## **Upcoming changes to IMC 0305, “Power Reactor Assessment Program”**

## Staff White Paper

## FAQ

FAQ 09-04

Figure D-1. The Physical Boundary of Outside Management Control

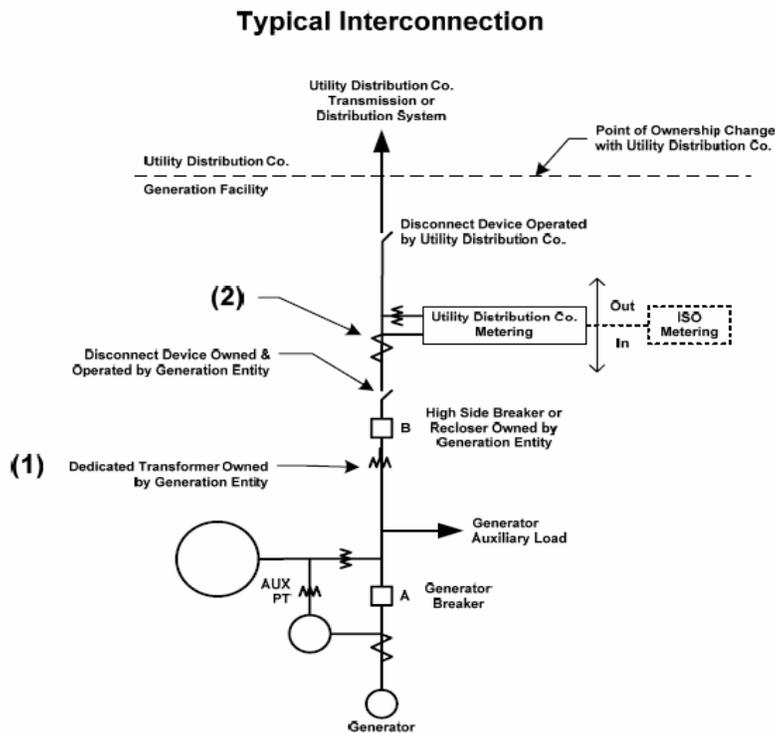
This FAQ seeks clarification to the Unplanned Power Changes Per 7000 Critical Hours Performance Indicator guidance. There has been industry discussion as to whether or not activity and equipment in an local electrical switchyard at a nuclear facility is under the direct control of the nuclear plant management and within the scope of this Performance Indicator. Revision 5 of NEI 99-02 page 15 lines 8-10 state: ***“Power changes directed by the load dispatcher...for grid stability, or for nuclear plant safety concerns arising from external events outside control of the nuclear unit are not included in this indicator. However, power reductions due to equipment failures that are under the control of the nuclear unit are included in this indicator.”***

NEI 99-02 does not specifically define “outside the control of the nuclear unit.” However, this terminology could be interpreted consistently with other industry uses of the same terminology. The IEEE 762 definition of “outside the control of plant management” is incorporated into the North American Electric Reliability Corporation’s (NERC) Generation Availability Data System (GADS) reporting.

To clarify the physical boundary for “outside the control of nuclear plant management,” the following statement will be added to NEI 99-02, page 15, after line 12:

11 However, power reductions due to equipment failures that are under the control of the nuclear  
12 unit are included in this indicator. **For the purposes of this performance indicator, switchyard electrical distribution equipment and maintenance beyond the first inter-tie with the offsite distribution system is not considered “under the control of the nuclear unit” when the equipment is not owned by the nuclear operating company, and the maintenance is being performed by personnel other than nuclear operating company employees. Transients caused by work activities performed by nuclear operating company employees in the switchyard are considered within the scope of this indicator.**
